## **MICRON PUMP STATION WELL PUMP NO. 4**

**SAWS Job No. 16-6004**

### **ADDENDUM NO. 1**

**March 12, 2020**

SAN ANTONIO WATER SYSTEM  
MICRON PUMP STATION  
ELECTRICAL SITE LAYOUT

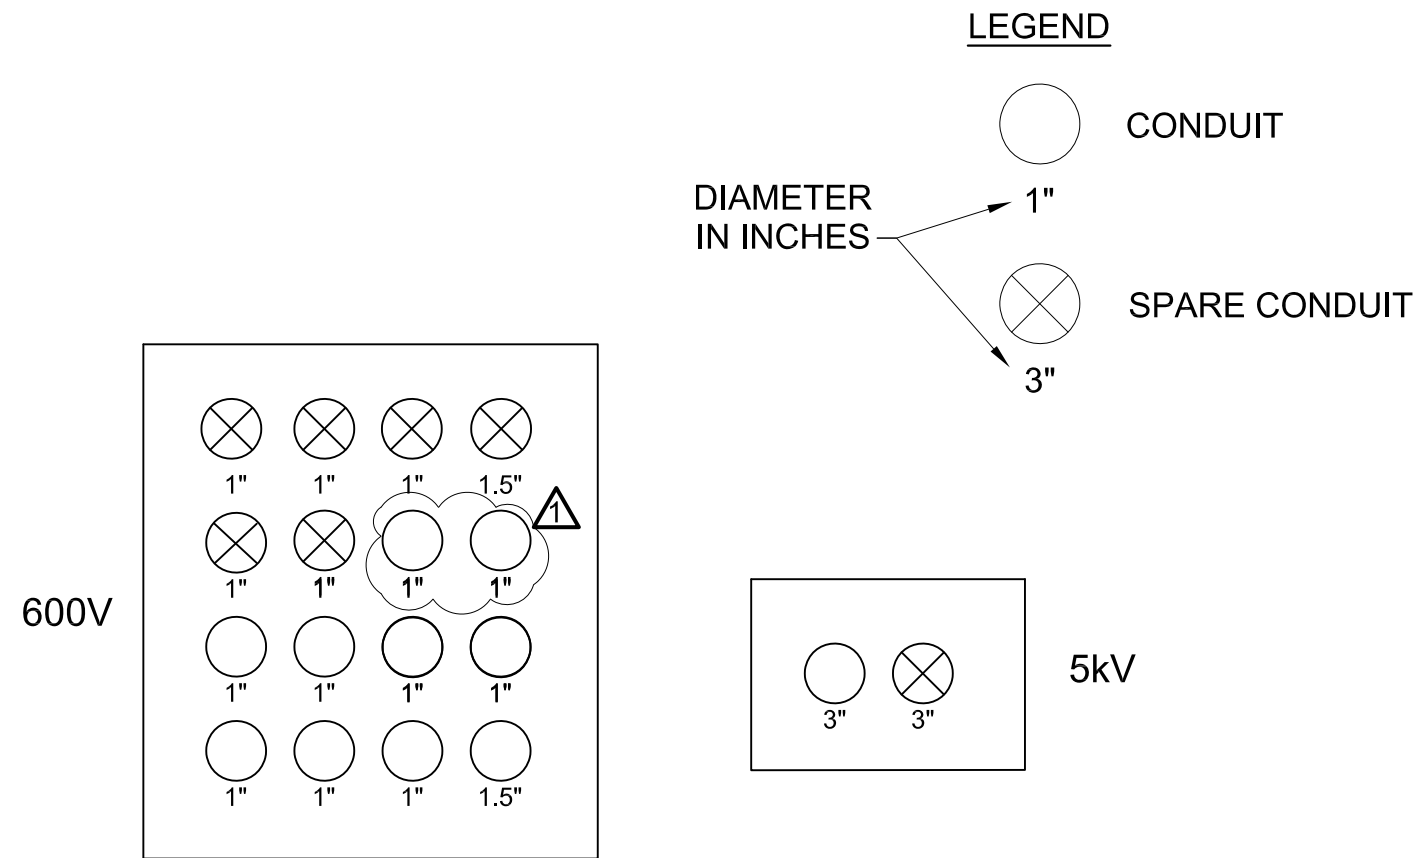
**Question 3: Electrical sheet E-2.1 One-line diagram and Keyed Note 11 on Sheet E-1.1 shows a 5kV rated Motor Disconnect at the well pump, however there is no specifications for the disconnect switch. Specifications does however refer to a Power Factor Correction Capacitor, which does not show on the One-line diagram nor the site plans. Please clarify.**

**Question 7: Pump motor control wiring to Well Pump Control Panel to Motor Starter as required on Sheet E-4.1 is missing from the Ductbank sections. Please clarify whether to utilize designed spares or new conduits are to be included in the Ductbanks and the cable type to be used.**

*Response: Please see revised Electrical Drawing E-1.1 sealed for additions of wiring and spare conduit.*
